UNITED STATES PATENT AND TRADEMARK OFFICE

| APPLICATION NO. | FILING DATE | FIRST NAMED INVENTOR | ATTORNEY DOCKET NO. | CONFIRMATION NO. |
|-----------------|-------------|----------------------|---------------------|------------------|
| 09/585,134 | 06/01/2000 | Stephen H. Albertson | TRACKER.001C1 | 4568 |

| Office Action Summary | Application No. 09/585,134 | Applicant(s) ALBERTSON ET AL. | |

DETAILED ACTION

**FIG 2**

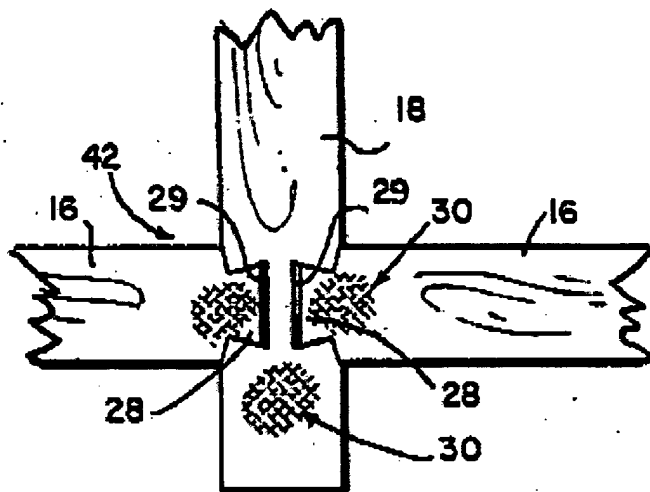
Campbell teaches a building kit, with the interconnecting parts 16/18 both color coded so that they can be correctly matched. Referring to the parts, "18" can be considered the fastener and "16" and "16" considered the connectors preselected to use with a specific fastener. Examiner notes that she is not physically combining the two references, only using Campbell to teach that fasteners and connectors can be color coded to match so that the proper fastener is used with a corresponding connector. The fastener remains the Dickson fastener (nail). Clearly, the color indications "30" of

Campbell are visible from a distance of at least 10 feet by a person with normal vision, as the colors are applied at the ends of structural members clearly larger than the head of a nail, no matter how large the nail, as shown in Fig 2 below.

Therefore, it would have been obvious to one of ordinary skill in the art, having the teachings of Dickson and Campbell before him at the time the invention was made, to modify Dickson as taught by Campbell to include coloring the tops of the fasteners to be highly visible, in order to obtain identification "at a glance". One would have been motivated to make such a combination because easily identifiable markings leading to faster and more accurate use of fasteners would have been obtained, Dickson teaches that it is important for the building inspector to identify the proper fastener "at a glance".

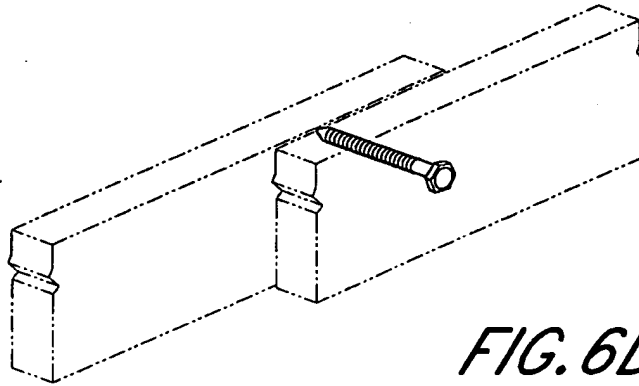
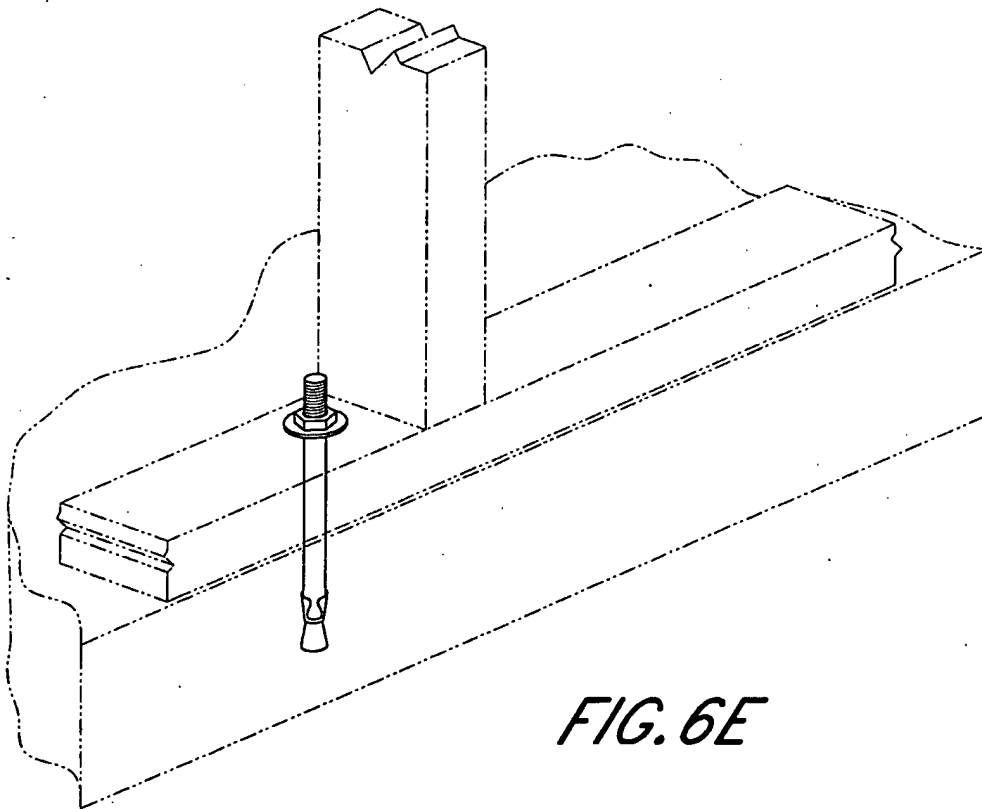
1. Applicant has added to sheets of drawings in response to a drawing objection that certain fasteners were not shown. Examiner agrees that one of ordinary skill in the art would immediately recognize such fasteners, and does not believe any new matter has been introduced in merely showing well-known fasteners in phantom joints; thus the drawings are approved.
